STAFF REPORT
COMMUNITY DEVELOPMENT DEPARTMENT

DATE: 4/13/2021
 TO: Mayor & City Council
 FROM: Joseph Dodson, Associate Planner
 208-884-5533
 SUBJECT: FP-2021-0009
 Teakwood Place Final Plat

PLAT SHOWING
TEAKWOOD PLACE SUBDIVISION
LOCATED IN THE NW $\frac{1}{4}$ OF THE NW $\frac{1}{4}$ OF SECTION 29,
T.3N., R.1E., B.M., ADA COUNTY, IDAHO
2021

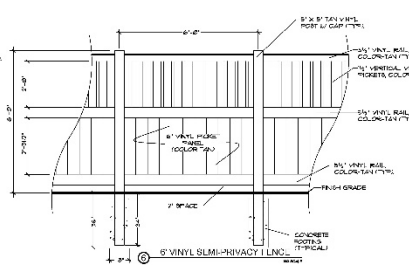
3. Prior to submittal for the City Engineer's signature, have the Certificate of Owners and the accompanying acknowledgement signed and notarized.
4. Prior to signature on the final plat by the City Engineer, the final plat prepared by Idaho Survey Group, LLC (Exhibit B), dated January 23, 2021, shall be revised as follows:

- a. Add a note stating: "This development is subject to the City of Meridian Development Agreement, Inst #2021-002167."
 - b. Add a note that Lot 3, Block 2 contains a pedestrian access easement along its northeast property line and include the recorded instrument number.

- c. Revise the street names on the plat per the Ada County Street Name Review response letter.
 - d. Add a note stating: The bottom of structural footing shall be set a minimum of 12-inches above the highest established normal ground water elevation.

- e. Add a note stating: Maintenance of any irrigation and/or drainage pipes or ditches crossing a lot is the responsibility of the lot owner unless such responsibility is assumed by an irrigation/drainage entity or lot owner's association.

- f. Revise Note #2 to name the appropriate irrigation district instead of "The City of Meridian."
5. Prior to signature on the final plat by the City Engineer, the landscape plan prepared by Leavitt & Associates Engineers, Inc. (Exhibit C), dated November 16, 2020, is approved as submitted.
